Asopen

5^{open}.70

UPGRADING January 31st 2008

From Jan 31st 2008, in agreement with the Group Finot Conq, it has been decided to bring the below modifications on Open 5.70 models :

PHILEAS BOATS OPEN 5.70
31.01.2008
BOOM VANG

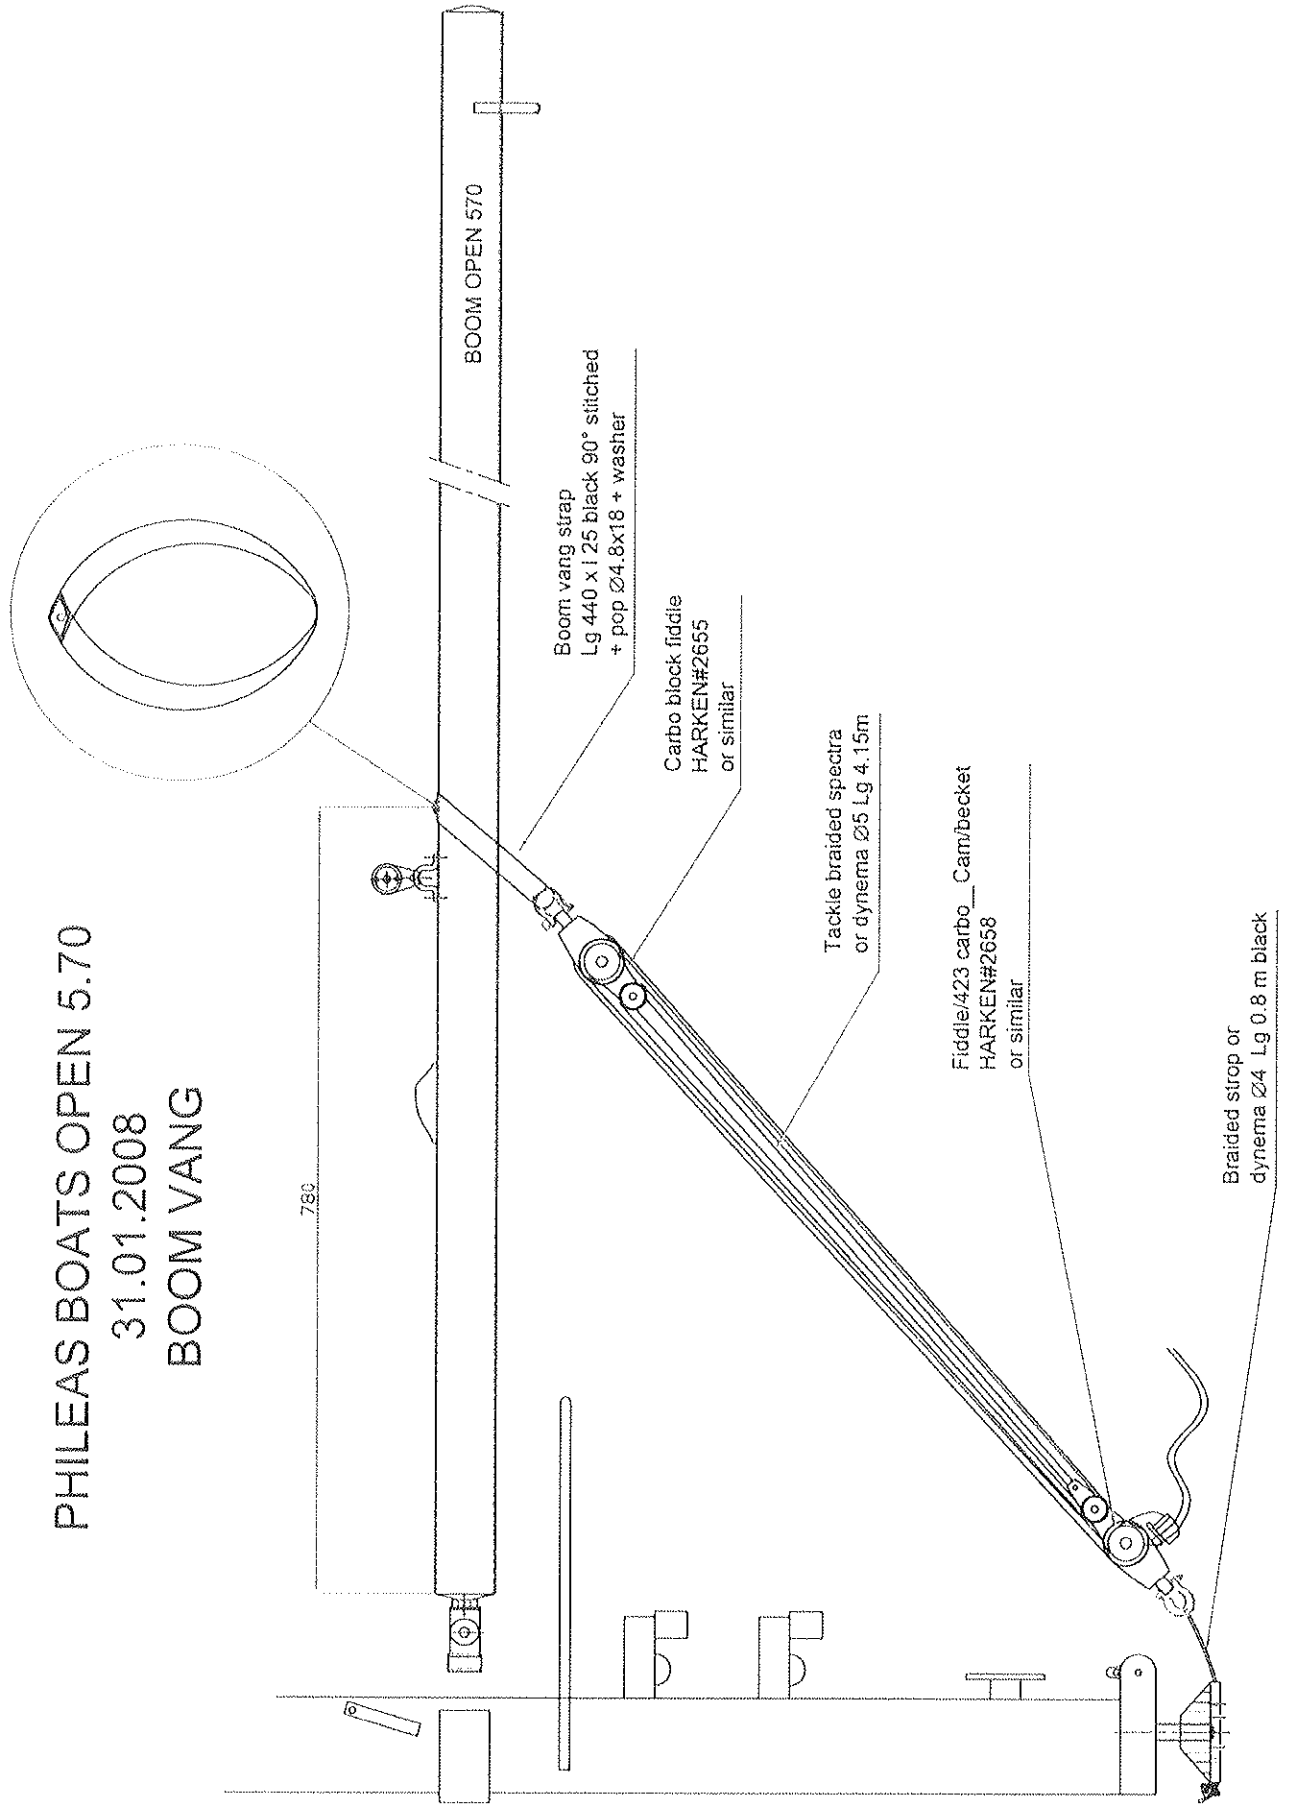
Boom Vang :

Open 5.70 are now supplied with a boom vang located as per attached sketch :

The boom vang is supplied complete with :

- 1 X stitched strap (L= 0,43 m l=25 mm) fastened to the boom thanks to a 5 mm diam. pop rivet and washer.
- 1 X fiddle /423 carbo-cam/ becket HARKEN # 2658 or similar
- 1X carbo block fiddle HARKEN # 2655 or similar
- 1 X Spectra or Dynema diam 4mm L=0,8 m
- 1 X Spectra or Dynema diam 5mm L=4,15 m

No further modification will be authorised ; main purpose of the boom vang is to maintain the tension of the main sail leech before the wind (specially when sheet is firmly eased out , which is not recommended).

All Open 5.70 supplied before January 31st 2008 have to be fitted with the described boom vang.
